Subject: FW: NYM/2019/0874/LB & NYM/2019/0870/FL The Woodlands, Sleights, Whitby --
Proposed roof lights.
Importance: High

PROJECT: Flat 11, The Woodlands Sleights, YO21 1RY

Drawing: Existing and Proposed Floor Plan

DRAWING: Proposed Elevation and Roof Plan

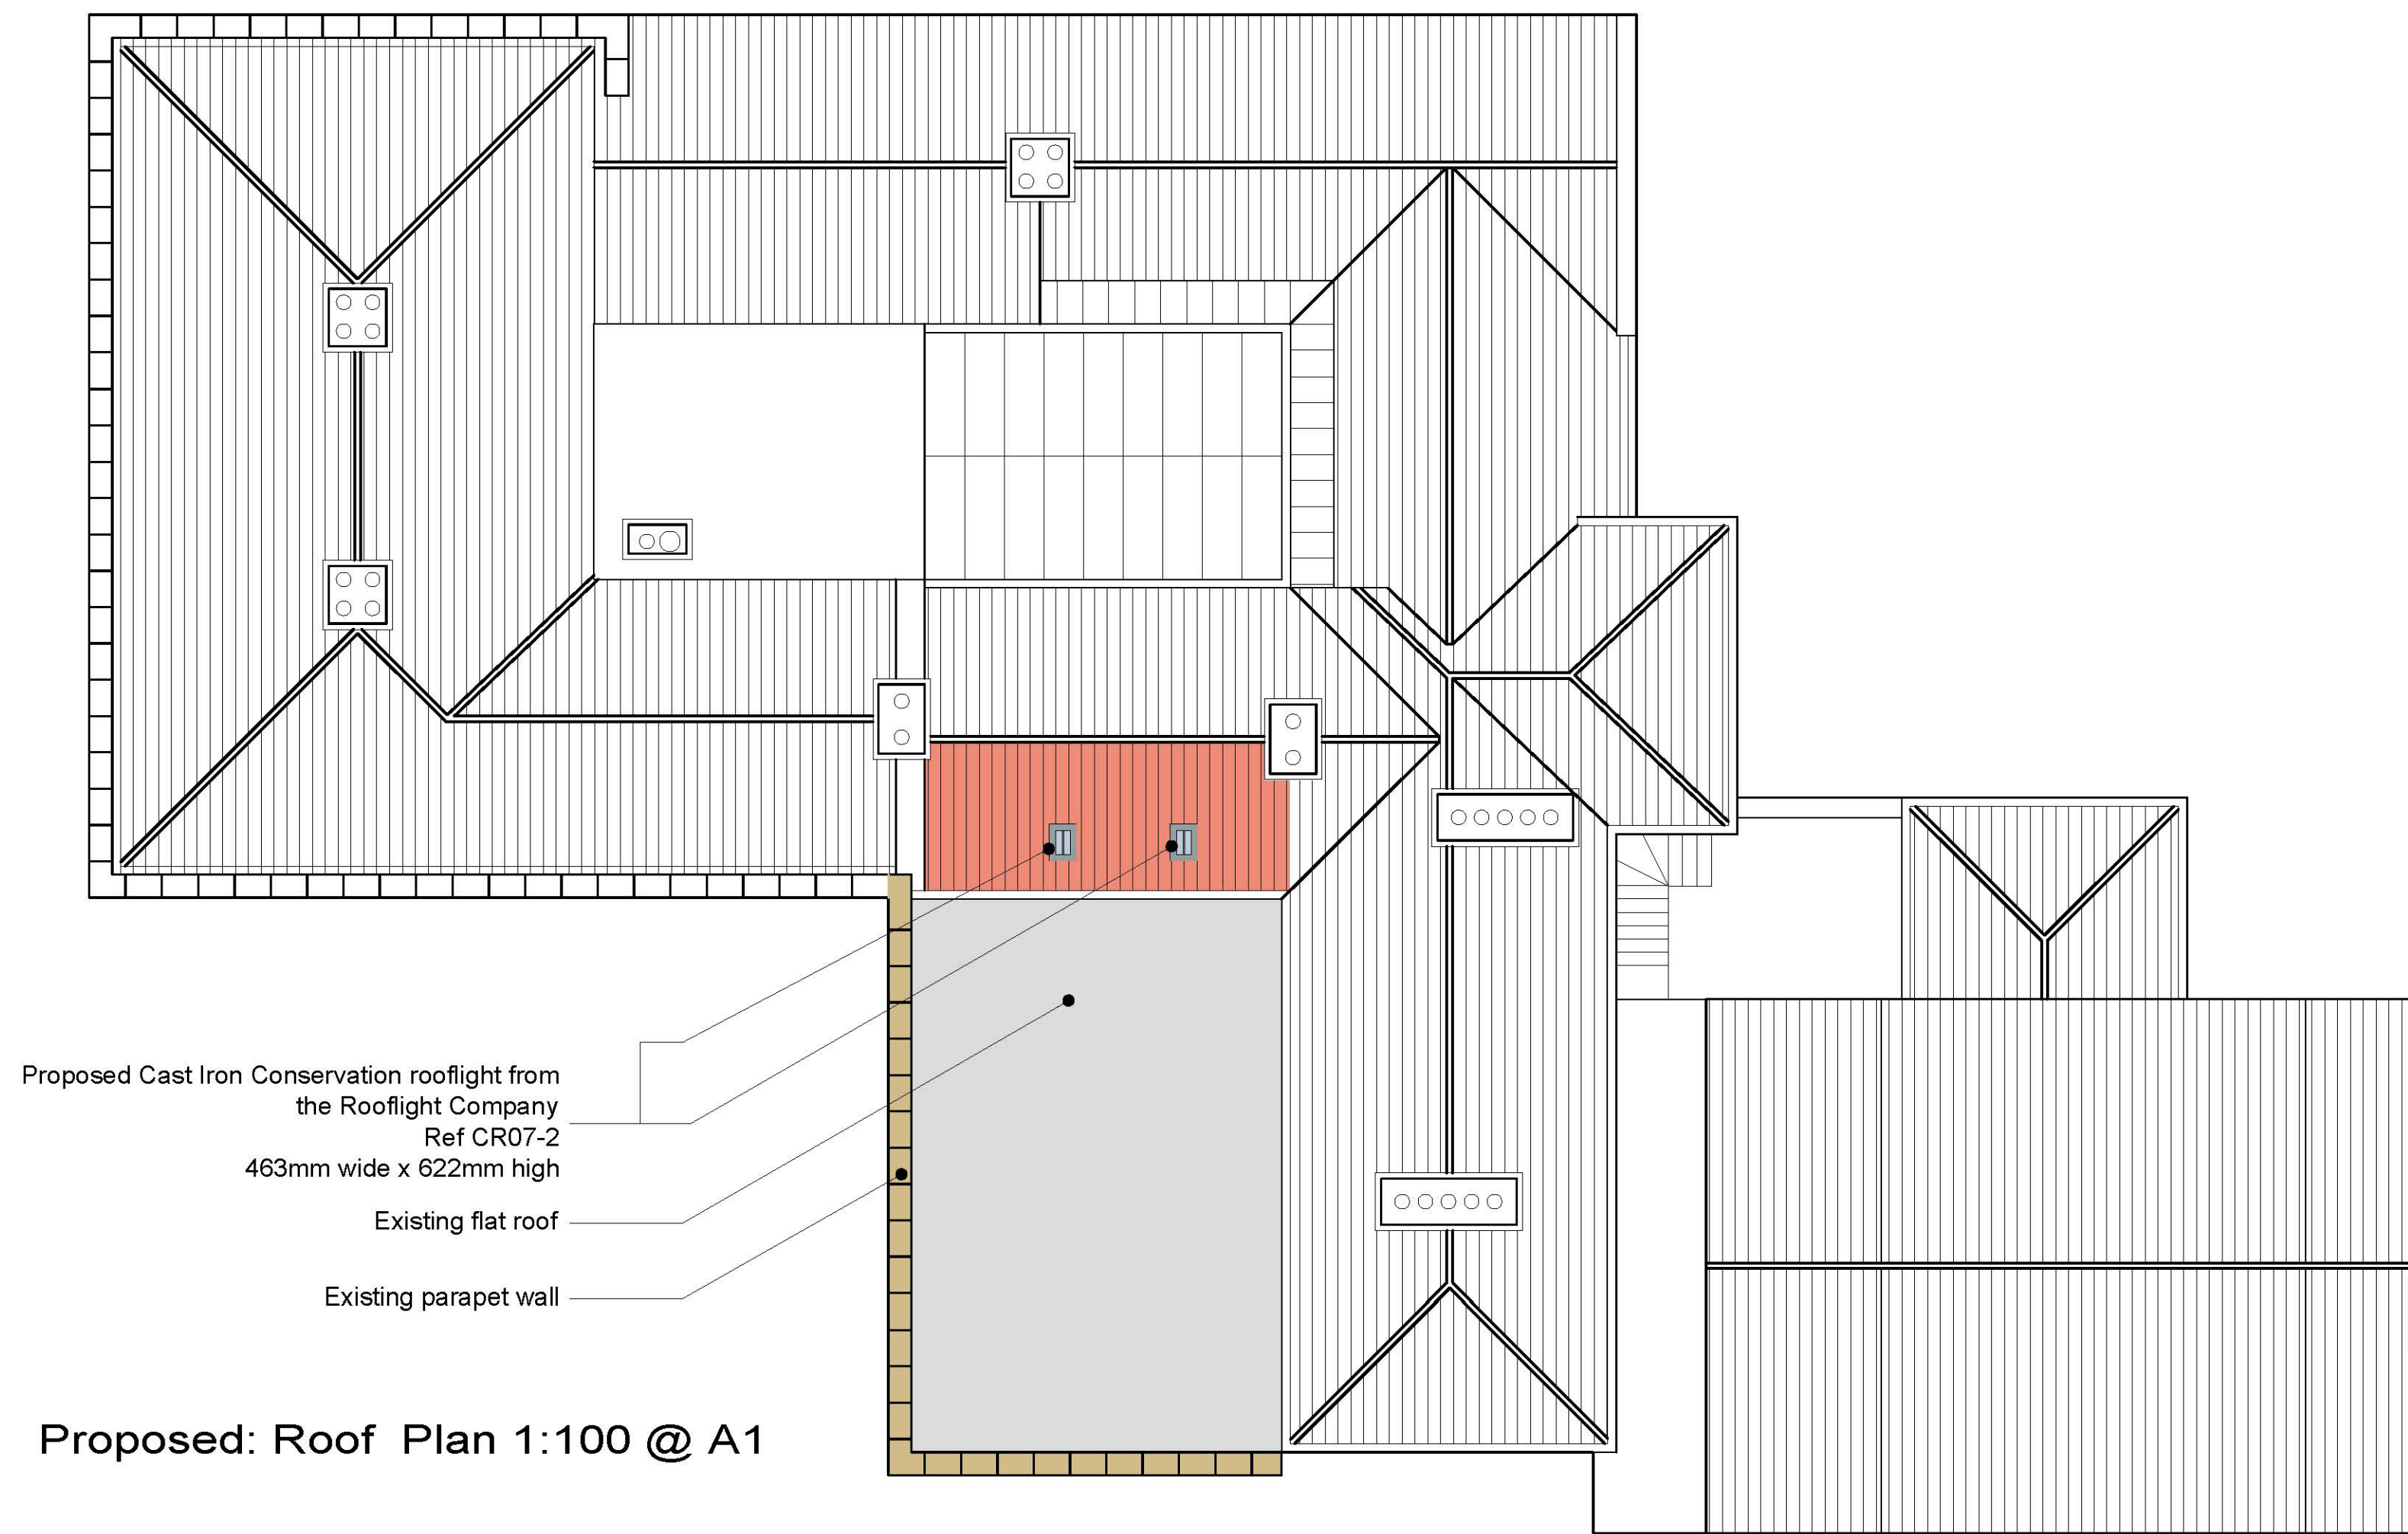
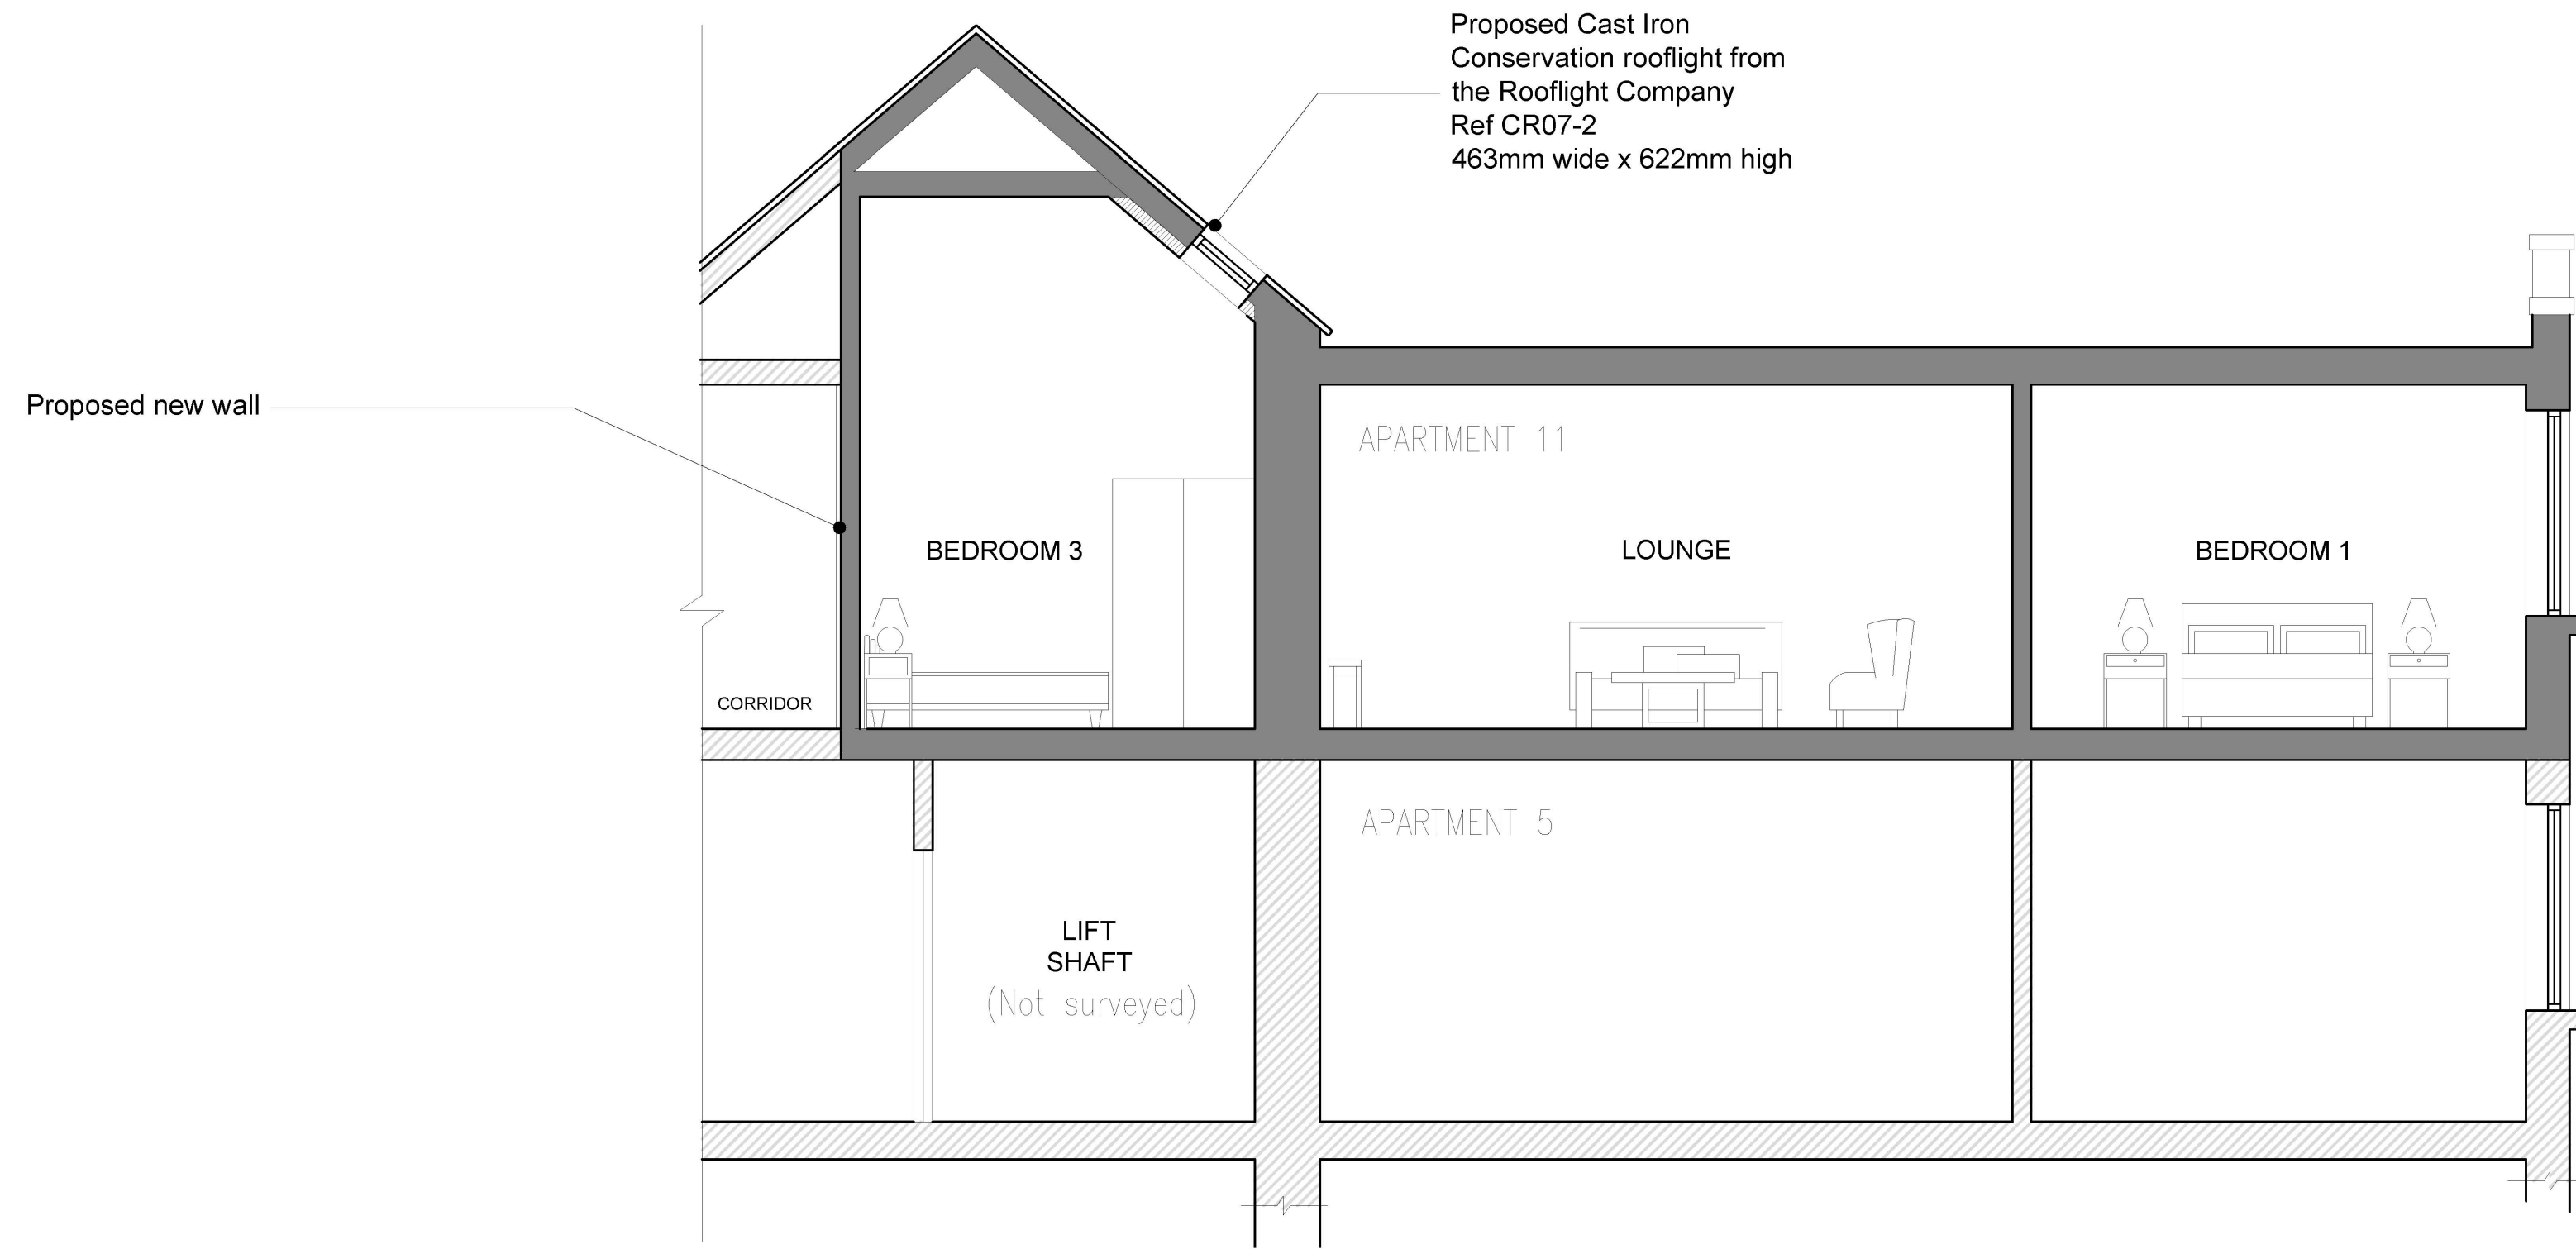
4. It is understood that the symmetry which was referred to in previous correspondence is very important to this elevation and the host property. Therefore this proposal now shows the two small conservation rooflights suggested in your letter which are 2 no. cast-iron rooflights ref CR07-2 463mm wide x 622mm high with a viewable glass size of 263 x 462mm from the Rooflight Company, who are a manufacturer widely considered acceptable for use in Listed buildings within the National Park.

5. The symmetry of these proposed smaller rooflights combined with the reduction in height and dark grey / black frames ensures that they are unseen above the castellated parapet wall around the flat roof area of the apartment. As a result the visual impact is virtually zero when viewed from the adjacent grounds and absolutely minimal when viewed from distance.

6. Given that the initial submission consisted of one rooflight at 780mm wide x 980mm high plus a sun tube at 460mm square the reduction in size of the rooflight can be seen to be very significant in that this equates to around 33.3%. This reduction combined with the replacement of the sun tube with a matching smaller rooflight provides the symmetry which was previously requested.

Proposed Cast Iron Conservation rooflight from the Rooflight Company Ref CR07-2 463mm wide x 622mm high
 Existing flat roof
 Existing parapet wall

REV	DATE	BY	AMENDMENT
F	19.02.20	MK	Rooflights revised
E	06.02.20	MK	Rooflights revised
D	24/12/19	CE	Rooflights altered
B	23.12.19	MK	Proposal revised
A	19.12.19	MK	First Issue
